Access Compliance Report Public Rights-of-Way (RR Crossings)

Intersection ID: 32449	Main Street: N_TRYON_ST	Location: N/A
ADA ID: 118AD46774E8	Overall Compliance: No	Severity Score: 0.0
Codes/Mitigation Info/Possible Solution		Field Measurements/Component Compliance

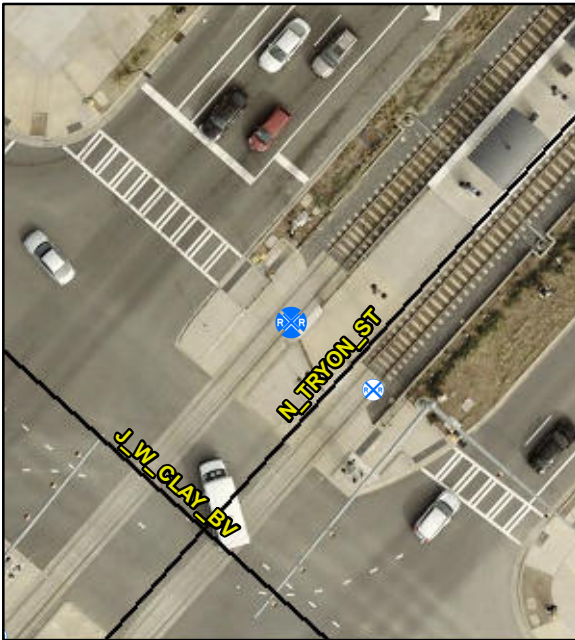
Remove & Replace Detectable Warning System. Provide Pedestrian Gate. Remove & Replace Walking Surface Adjacent to Rail.

R302.7.4, R305.1.4, R305.2.5

Compliance	Description	Data
Yes	DWS Provided?	Yes
Yes	DWS Contrast?	Yes
No	DWS Width (in)	No
Yes	DWS Length (in)	25.0
Yes	DWS Offset (in)	116.0
No	Pedestrian Gate?	No
N/A	DWS Outside Gate?	No
N/A	Rail Type?	LightRail
No	Flangeway Gap (in)	2.5
Yes	Sidewalk Width (in)	121.0
